SUMMARY OF CONCERNS IN RELATION TO THE PROPOSED NORTHCONNEX TUNNEL

This is an objection to many aspects of the proposed NorthConnex tunnel.

SECTION A: THE CONNECTIVITY OF NORTHCONNEX SOUTHERN VENTILATION FACILITY AT THE SOUTHERN INTERCHANGE, THE SOUTHBOUND TUNNEL IN PARTICULAR

MOTORWAY OPERATIONS COMPLEX - SOUTHERN VENTILATION FACILITY - SECTIONS
M1-M2-5000-DR-JD-0525

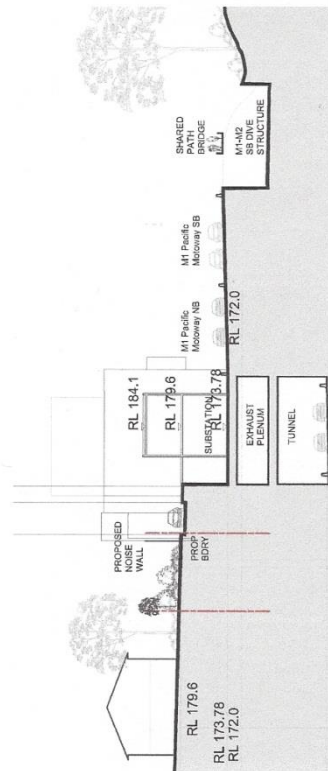
5. *EIS Volume 4, Technical working papers - Urban Design, 6.0 Operational Ancillary Facilities*
EIS Page 99 there is the diagram "Motorway Operations Complex – Southern Ventilation Facility – sections. *Page 10 below* The diagram has the cryptic label "Connection to tunnel TBC". What does TBC stand for? To be considered? Why is tunnel singular? Which tunnel is the diagram referring to northbound or southbound? There is no diagram showing any connection from the Southern Interchange ventilation facility to either the northbound or the southbound tunnel in any way
AND YET

- Diagrams need to be provided showing the inter-relation between the shaft, the ventilation outlet and the motorway operations centre with a clear description of what is to be constructed and how it will operate.
- The community needs irrefutable evidence that the polluted air from the southbound tunnel exit portals will not be allowed to flow like an invisible sewer through West Pennant Hills, North Rocks, Carlingford and Beecroft.

M1-M2-5000-DR-UD-0550
NORTHERN VENTILATION FACILITY - CROSS SECTIONS

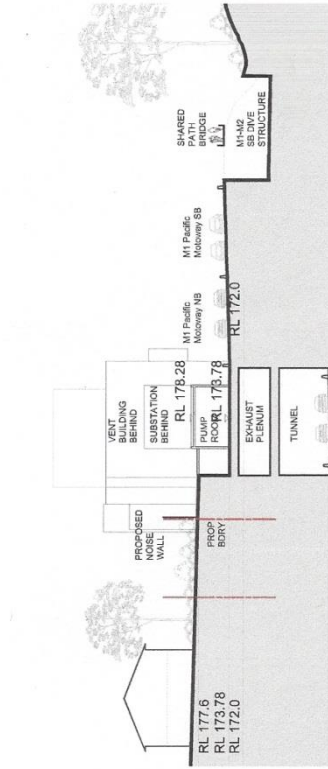
EIS page 135 *Page 11 below* there is a very explicit diagram showing the *Northern Ventilation Facility – cross section*.

M1-M2-5000-DR-UD-0556
NORTHERN VENTILATION FACILITY - LONG SECTION

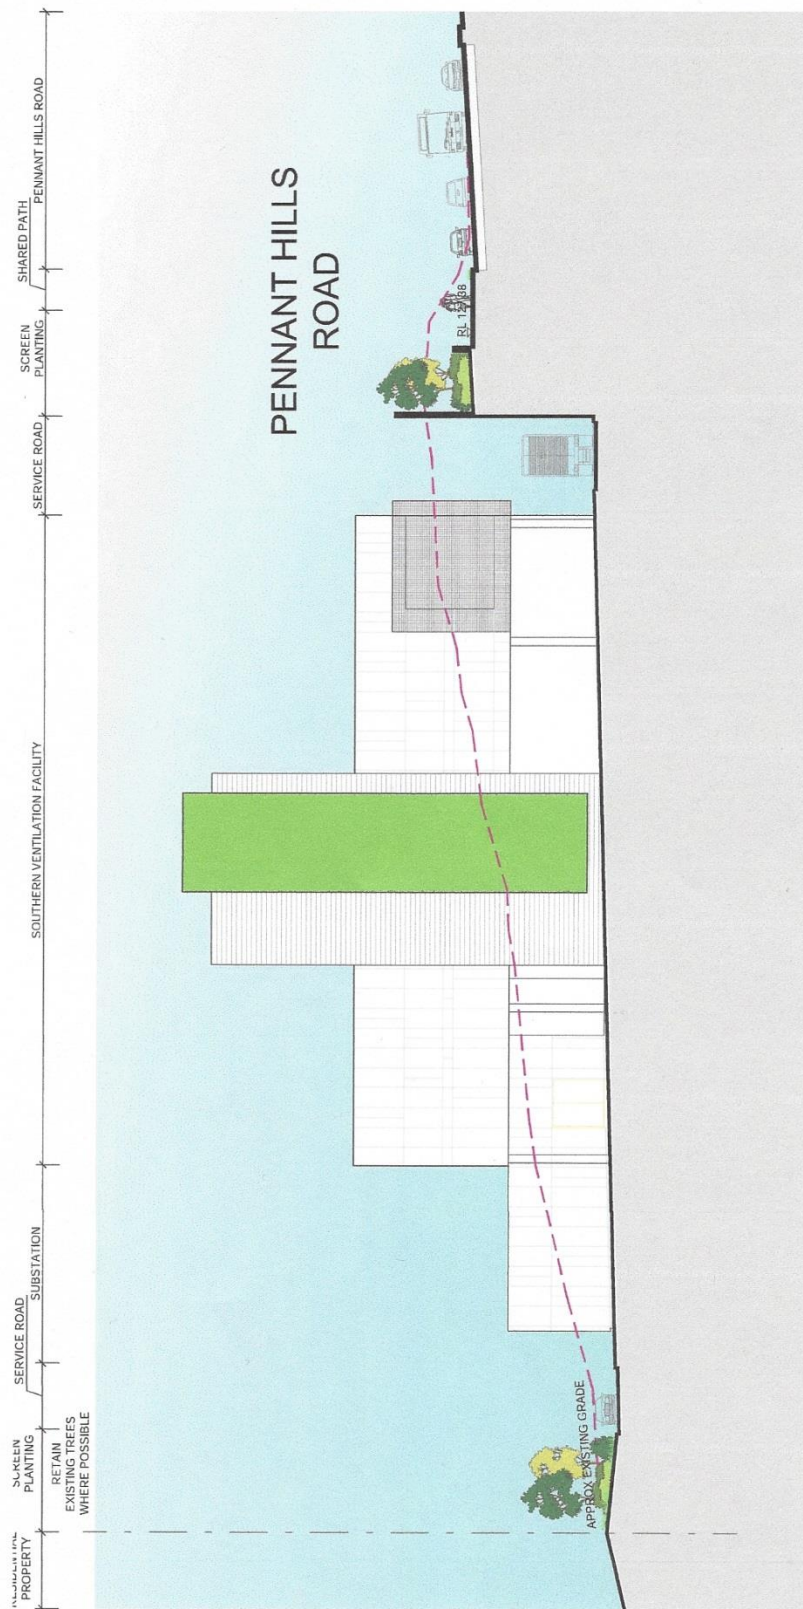
EIS page 134 *Page 12 below* there is a very explicit diagram showing the *Northern Ventilation Facility – long section*.
